Access Compliance Report

Public Rights-of-Way

(Curb Ramps)

Intersection ID: 12428	Main Street: E_7TH_ST	Cross Street: N_CALDWELL_ST	Location: W
ADA ID: 74DDA343958E	Ramp Type: PerpDiag	Initial Pass/Fail: Fail	Overall Compliance: No
Severity Score: 47.5			
Codes/Mitigation Info/Possible Solution		Field Measurements/Component Compliance

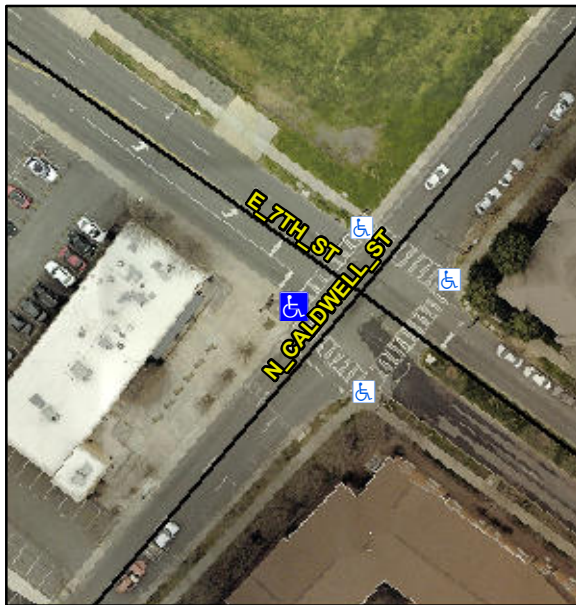
R304.5.1, R304.2.2

Compliance	Description	Data	Compliance	Description	Data
N/A	Ramp Length (in)	69.0	No	Ramp Slope (%)	10.7
No	Ramp Width (in)	29.0	Yes	Ramp XSlope (%)	1.7
N/A	Flare Type LT	N/A	N/A	Flare Type RT	N/A
N/A	Flare Slope LT (%)	N/A	N/A	Flare Slope RT (%)	N/A
N/A	Flare Traversable LT?	N/A	N/A	Flare Traversable RT?	N/A
N/A	Landing Length (in)	N/A	N/A	DWS Provided?	N/A
N/A	Landing Width (in)	N/A	N/A	DWS Contrast?	N/A
N/A	Landing Slope (%)	N/A	N/A	DWS Length (in)	N/A
N/A	Landing X Slope (%)	N/A	N/A	DWS Full Width?	N/A
N/A	Landing Curb? (Y/N)	N/A	N/A	DWS Offset (in)	N/A
N/A	Shared Landing?	N/A			
N/A	Gutter Ponding?	Yes	N/A	Gutter Slope (%)	N/A
N/A	Gutter Lip Ht (in)	2.0	N/A	Gutter X Slope (%)	N/A
N/A	Painted X Walk1?	Yes	N/A	Painted X Walk2?	Yes
	X Walk 1 Direction	To SE		X Walk 2 Direction	To NE
N/A	X Walk 1 Width (in)	105.0	N/A	X Walk 2 Width (in)	85.0
	X Walk 1 Slope (%)	2.1		X Walk 2 Slope (%)	1.3
	X Walk 1 X Slope (%)	0.1		X Walk 2 X Slope (%)	0.3

N/A	Ramp inside XWalk1?	Yes	N/A	Ramp inside XWalk2?	Yes
	Road Slope (%)	0.8	N/A	Clear Space?	N/A
	Road X Slope (%)	2.7	N/A	Clear Space to XWalk (in)	N/A
N/A	Any Obstructions?	N/A	N/A	Storm Grate/Utility Hazard?	N/A
	Obstruction Type			Storm Grate/Utility Type	
		N/A			N/A
		Yes		Surface Condition? (G/P)	Good

Remove & Replace Curb Ramp With Two New Directional Ramps or Equivalent.
